TOLEDO-LUCAS COUNTY PLAN COMMISSIONS

REF: SUP-4008-19

SUBJECT: Request for a Special Use Permit for a new school at 4747 Heatherdowns Boulevard.

SITE PLAN

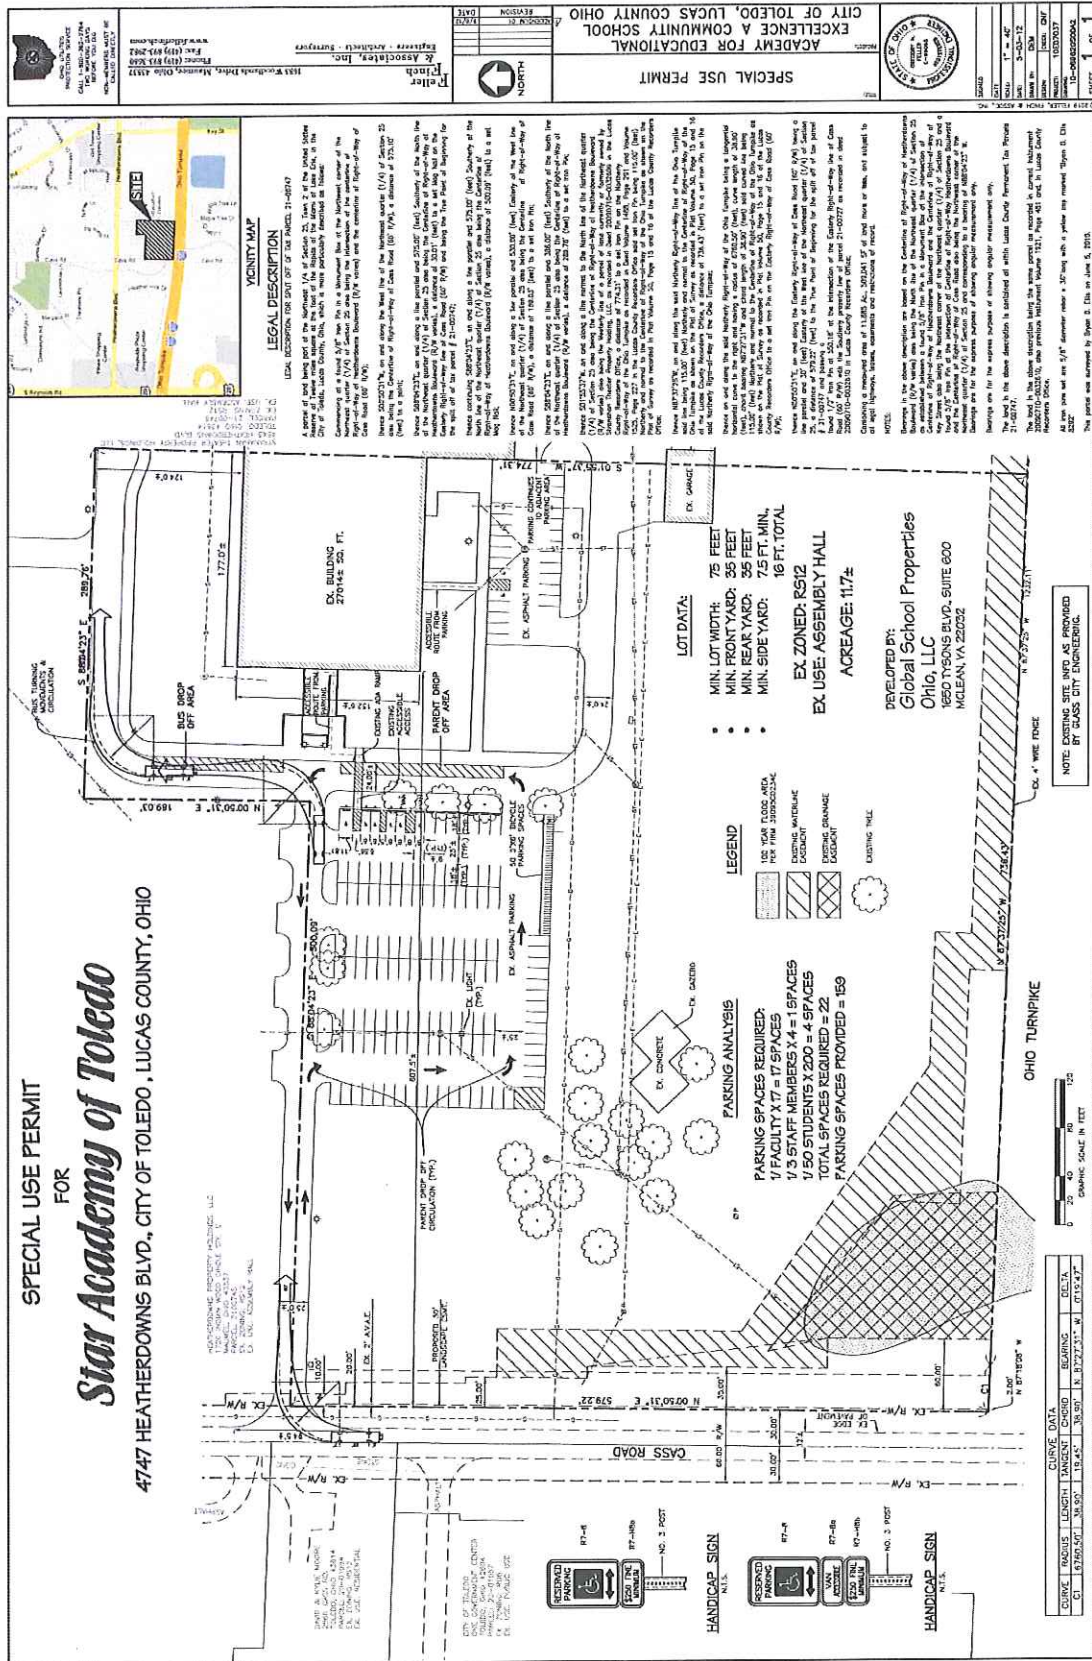
The site plan submitted depicts a total of 159 parking spaces with six (6) spaces designated for persons with disabilities and fifty (50) bicycle spaces, the maximum required. While the available parking provided is in excess of the maximum allowable parking spaces, 150% of the minimum parking requirement, an alternative parking plan will not be required because the parking is existing on site. Additionally, a shared parking/cross-access agreement shall be established and maintained with the property to the north in order to access the facility from Cass Road and Heathdowns Boulevard. In the event the cross-access is altered in any way, a re-review of the Special Use Permit shall occur and listed as a condition of approval.

The site plan submitted depicts a landscaping area thirty-foot (30') wide but does not depict any plantings in the greenbelt, terminal islands or around the foundation of the building. A Landscaping Plan shall be submitted depicting the frontage greenbelt, foundation plantings and landscaped terminal and listed as conditions of approval.

- a. A thirty-foot (30’) greenbelt is required along the Cass Road frontage and shall include one (1) tree per every thirty-foot (30’) of frontage; **not acceptable as depicted on site plan. A total of twenty (20) trees shall be installed along Cass Road and shall be depicted on a completed landscaping plan.**

- b. Foundation plantings for the full street-facing building elevation; and landscape areas at major building entrances. **Shall be depicted on a completed landscaping plan.**

- c. Landscaped terminal islands must be provided at the end of each parking. **Shall be depicted on a completed landscaping plan.**
 - d. Landscaped areas may not contain bare soil, aggregated stone or decorative rock. Any ground area must be covered with hardwood mulch, grass or other vegetative ground coverage.
